Co3237 Poultney BF 0145(13)

ADDENDUM #1

- Invitation for Bids, and Proposal to extend Bid Opening to June 13, 2025, and update the Schedule of Items.
- Special Provision Pages 1 and 6.
- Plan sheets 3, 10, 11, 44-52, 57, 63, 65, 79-82, 93, 94, 96, and 97.
- New Impact Plans shall replace Pages 136 to 171 in the Proposal.

PEDESTRIAN BRIDGE RAILING DETAIL

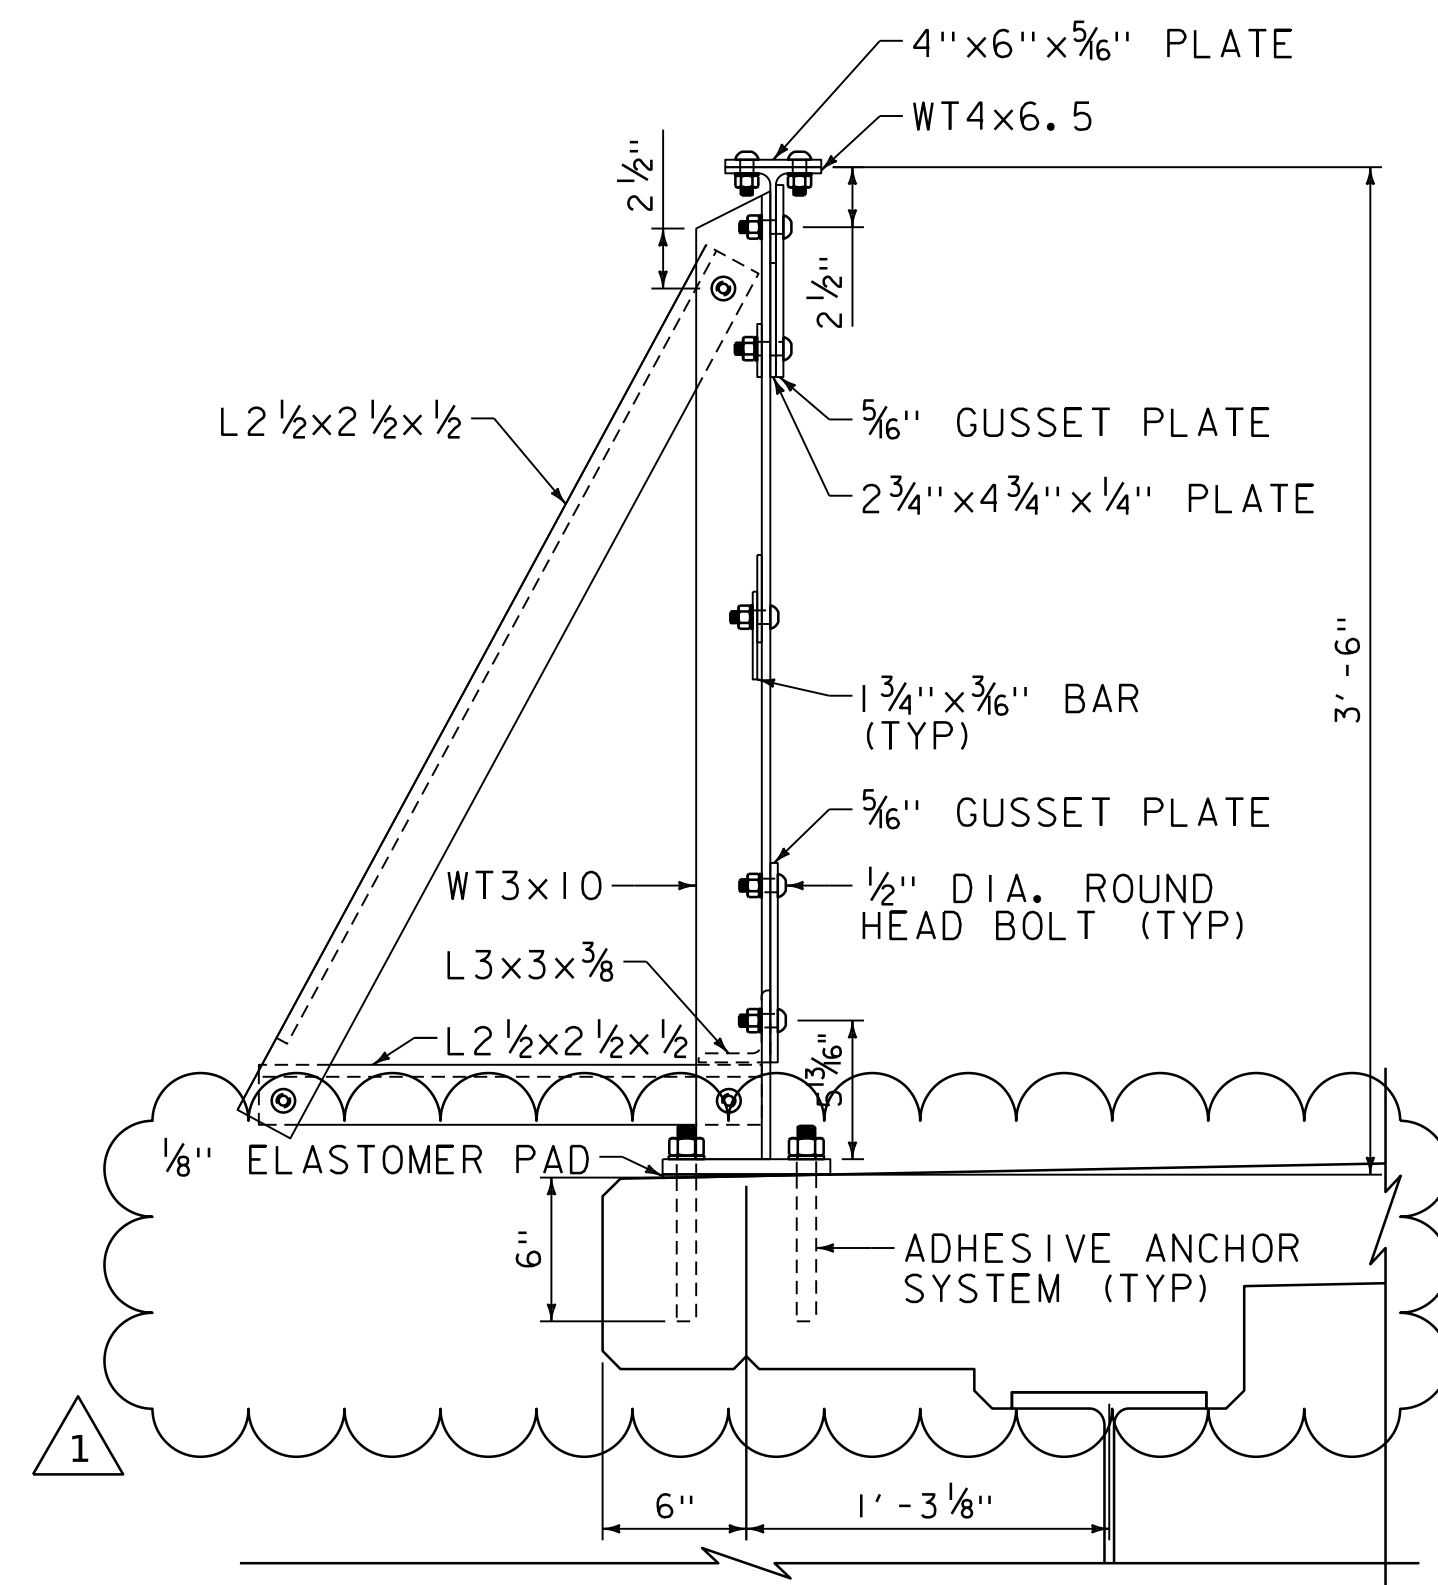
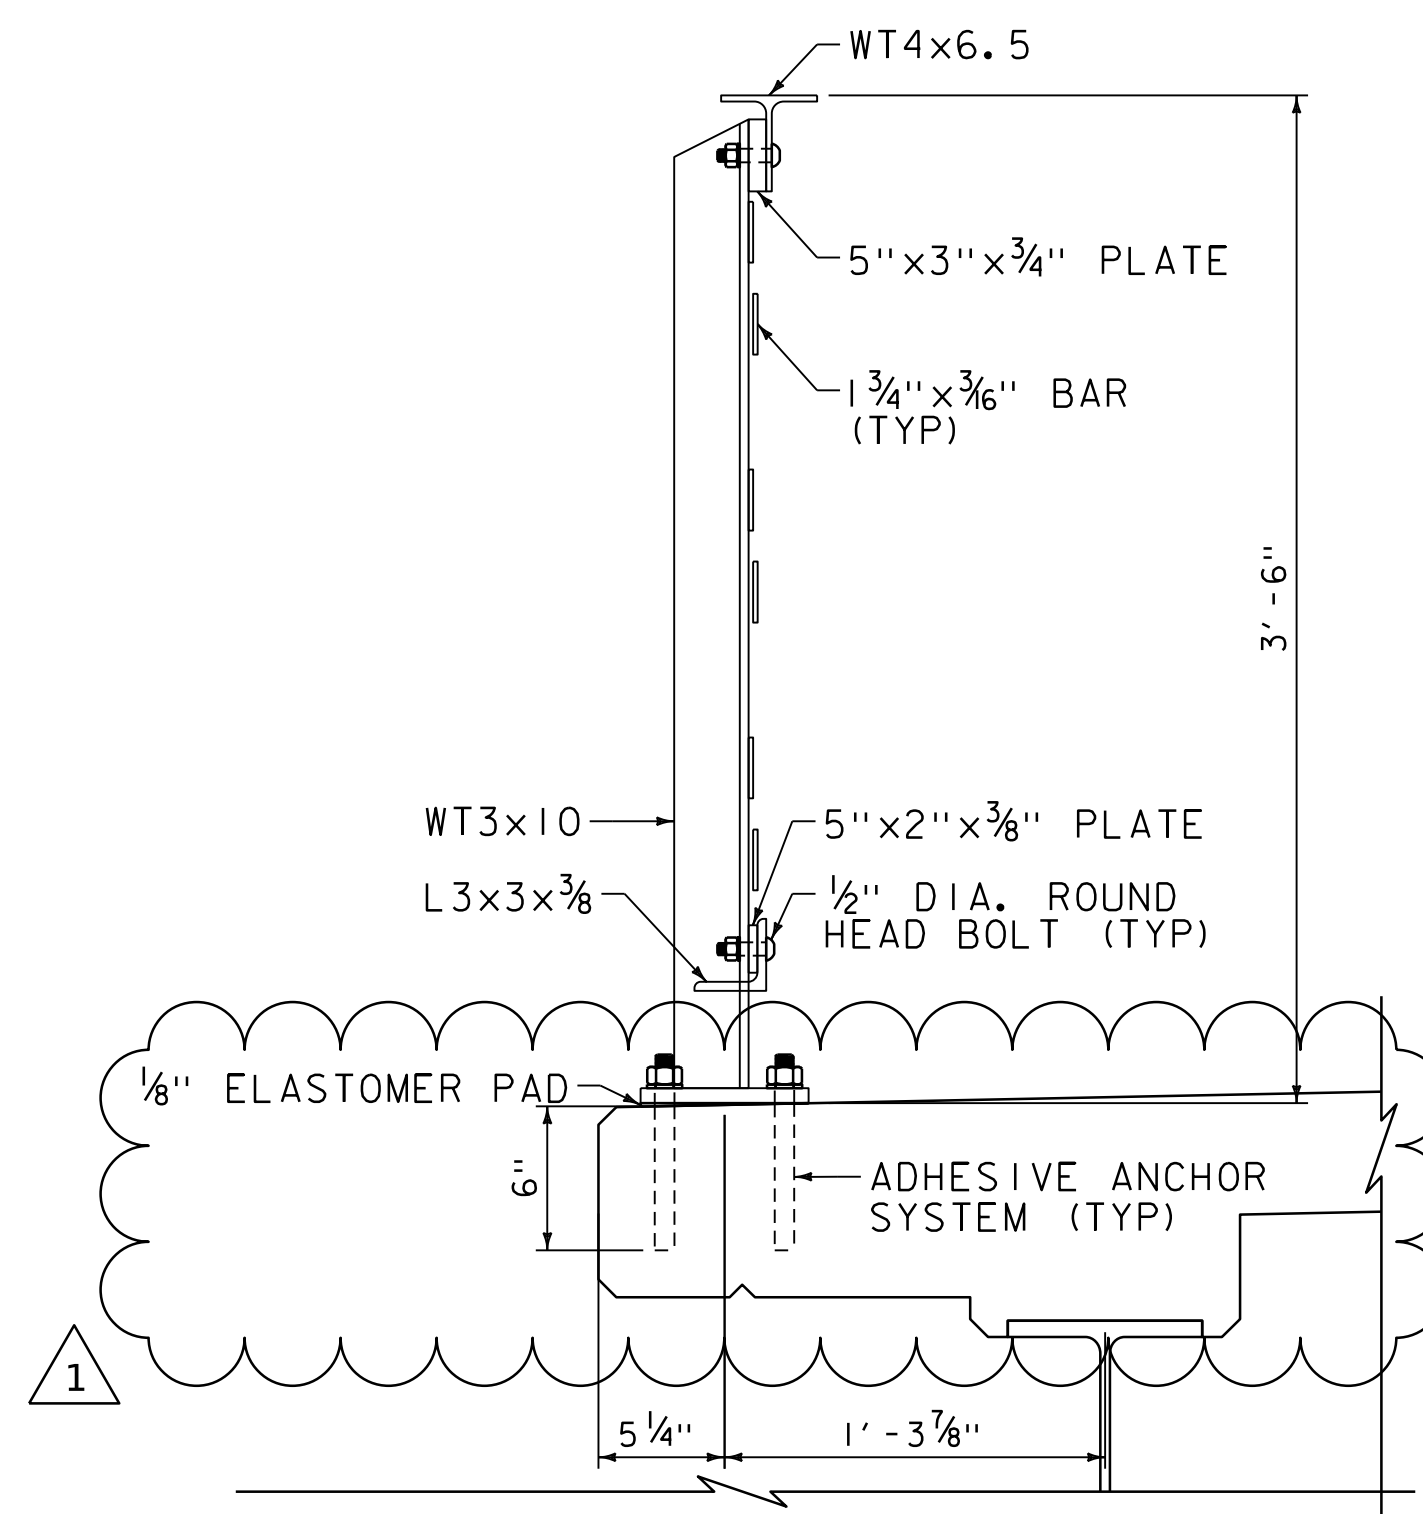
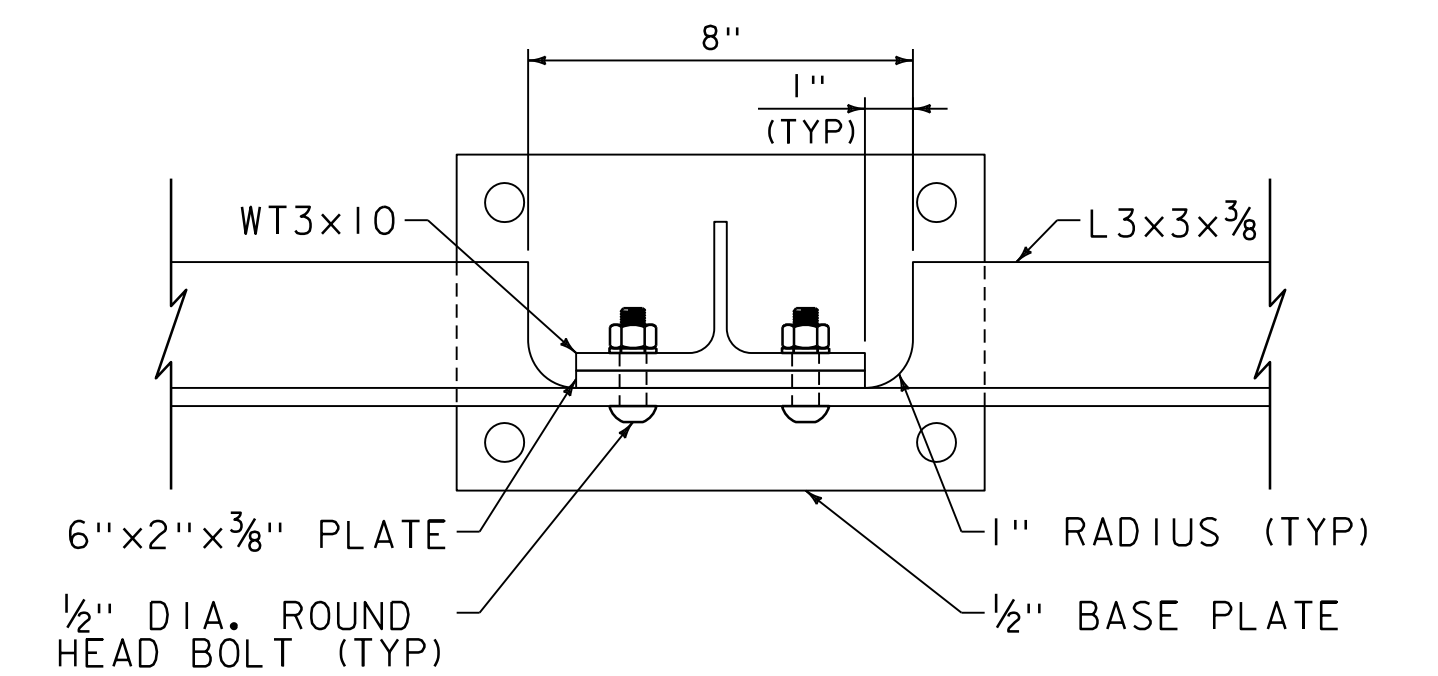
ADDENDUM	REVISION	PLOT DATE	DESCRIPTION	BY
1	1	5/19/2025	ADJUSTED ANCHORAGE TO ACCOMMODATE POST-INSTALLED ANCHORS, ADDED WELD TO ALL SIDES OF LATTICE CROSS, CHANGED "END POST" TO "POST AT SIDEWALK BRACKET"	MSWT

FILE NAME: z2lj64pedrail.dgn
PROJECT LEADER: J.D. KEENER
DESIGNED BY: M.S.W. THISTLE
PEDESTRIAN RAIL DETAILS (2 OF 2)

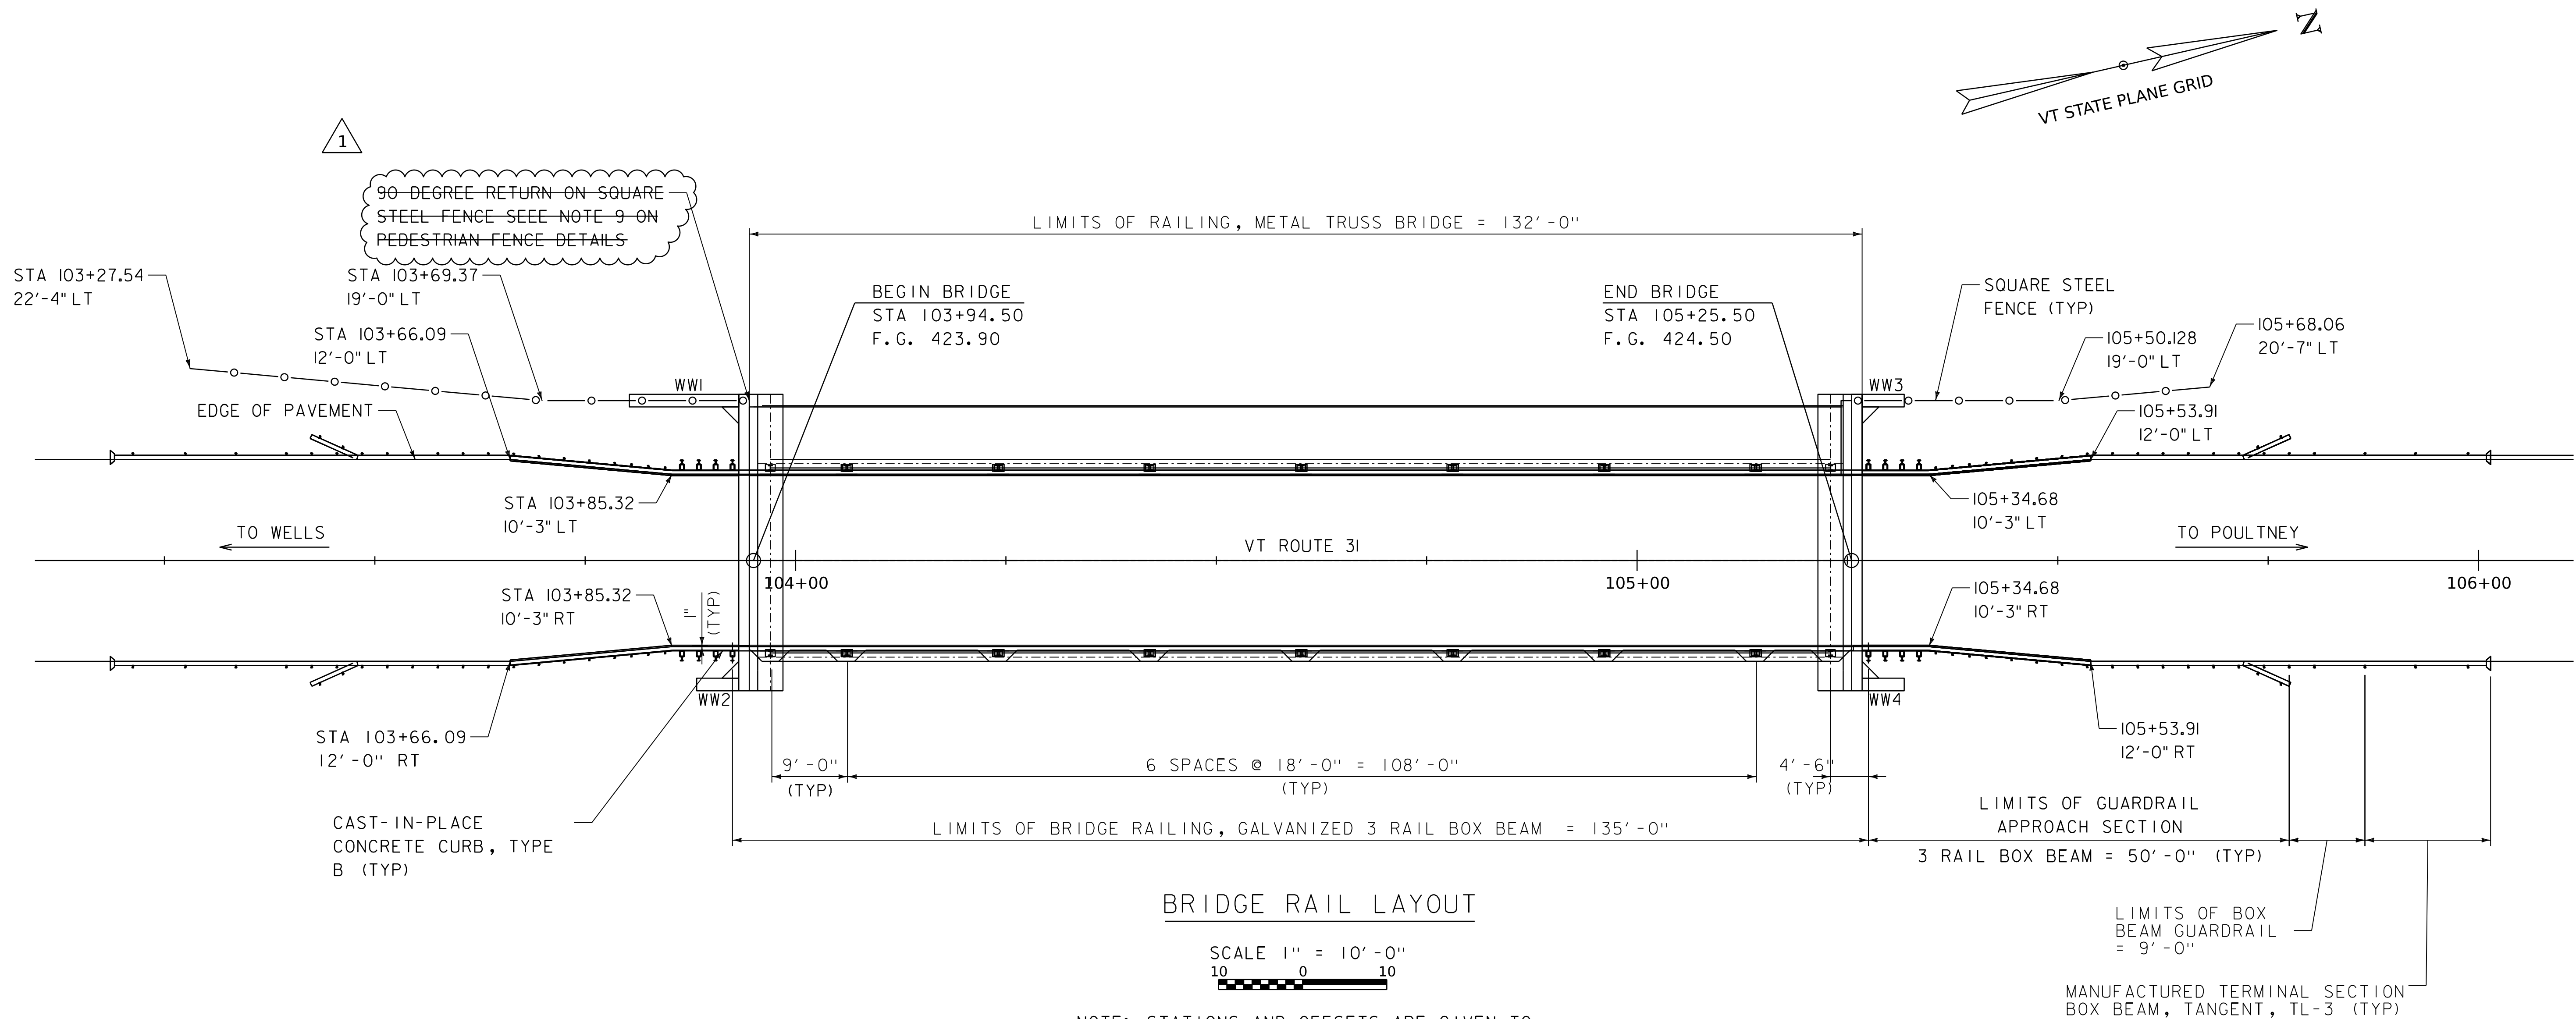
ADDENDUM	REVISION	PLOT DATE	DESCRIPTION	BY
1	1	5/19/2025	ADJUSTED ANCHORAGE TO ACCOMODATE POST-INSTALLED ANCHORS, ADDED WELD TO ALL SIDES OF LATTICE CROSS, UPDATED NOTES	MSWT

POULTNEY RIVER CROSS SECTIONS
STA. 10+60 - 10+70
SCALE 1" = 10' - 0"

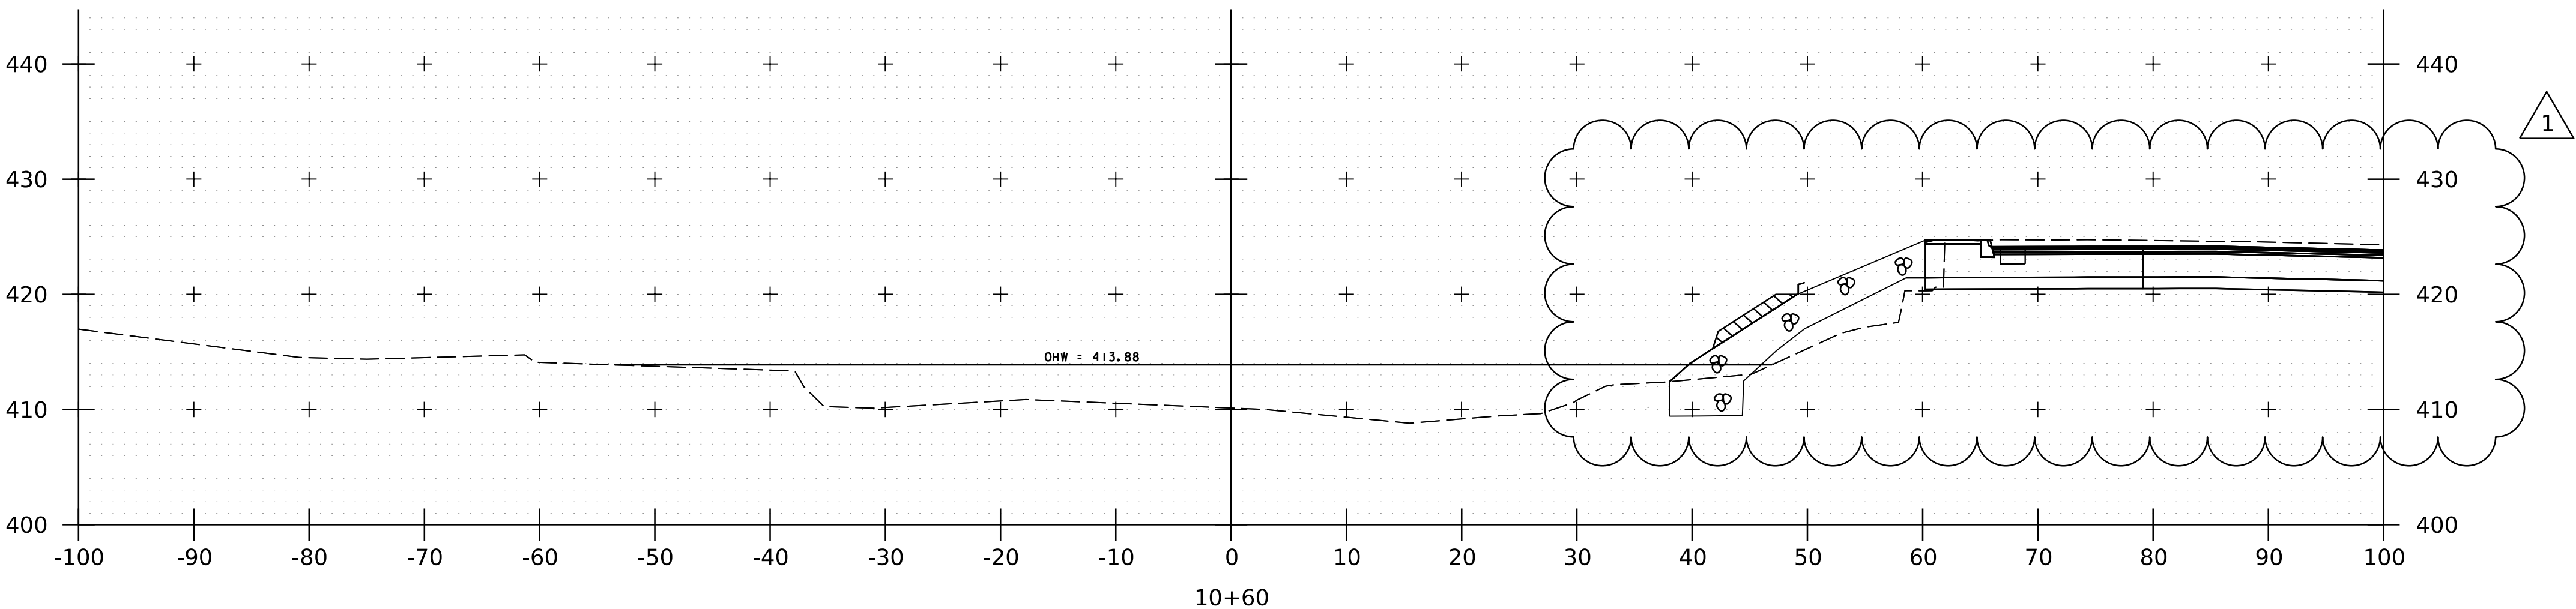
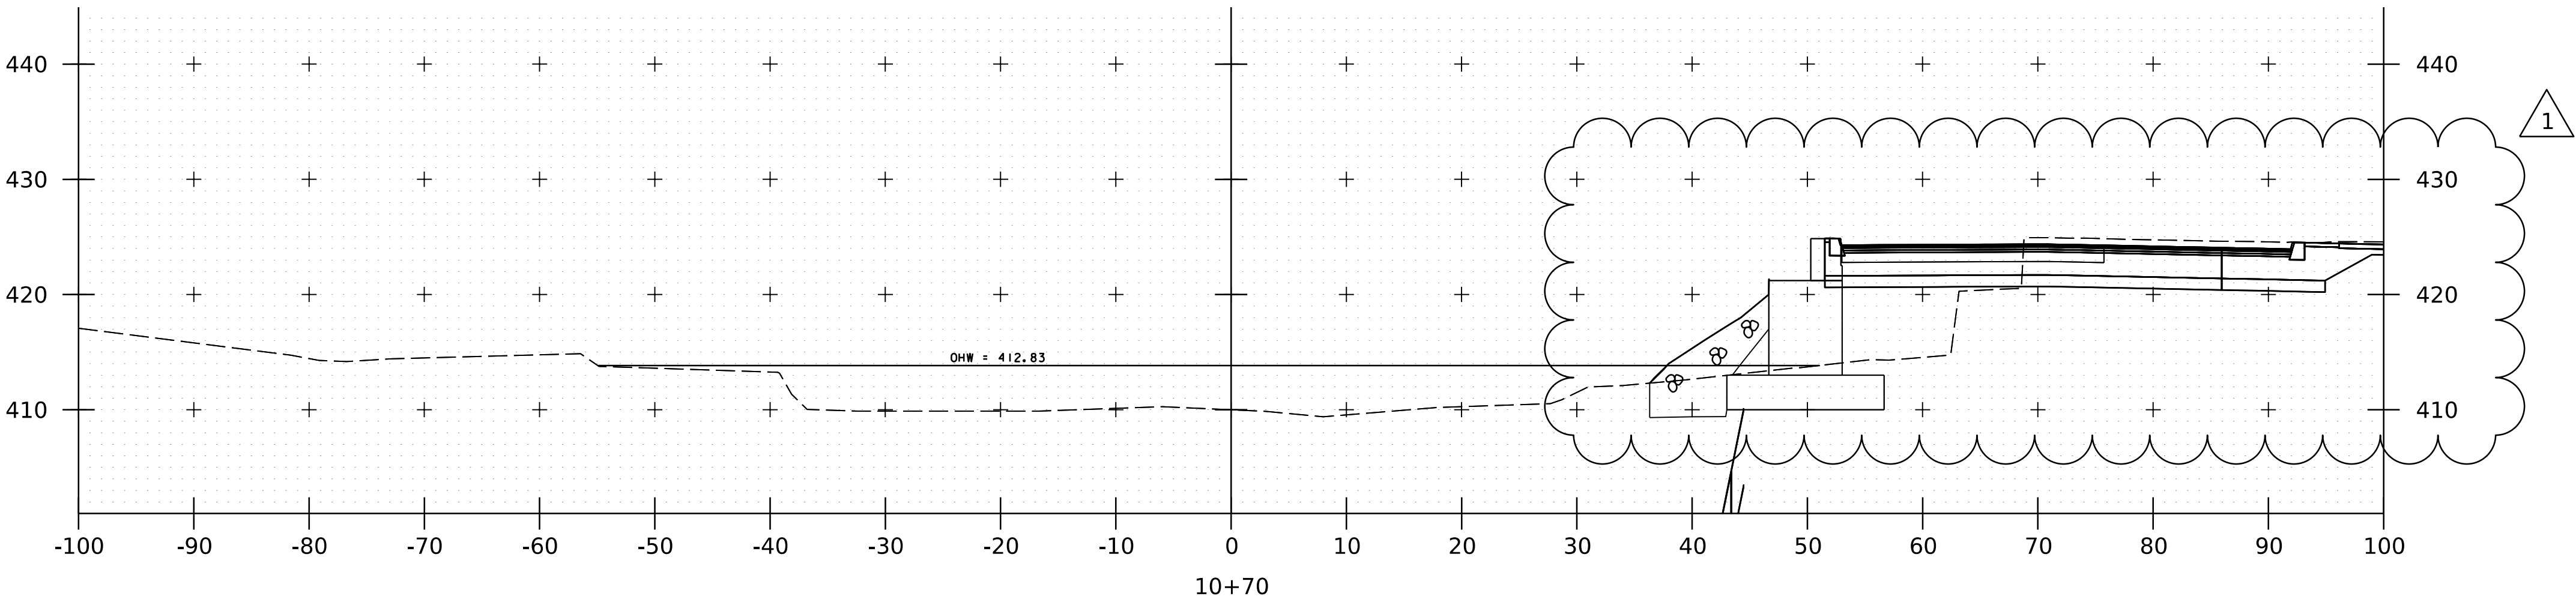
ADDENDUM	REVISION	PLOT DATE	DESCRIPTION	BY
1	1	19-MAY-2025	UPDATED FOR CURRENT ABUTMENT MODEL	MSWT
PROJECT NAME: POULTNEY				
PROJECT NUMBER: BF 0145(I3)				
FILE NAME: z2lj64xs_channel.dgn			PLOT DATE: 19-MAY-2025	
PROJECT LEADER: J.D. KEENER			DRAWN BY: T.D. BURT	
DESIGNED BY: N.A. TRUSLOW			CHECKED BY: J.D. KEENER	
CHANNEL CROSS SECTIONS SHEET (2 OF 8)			SHEET 93 OF 115
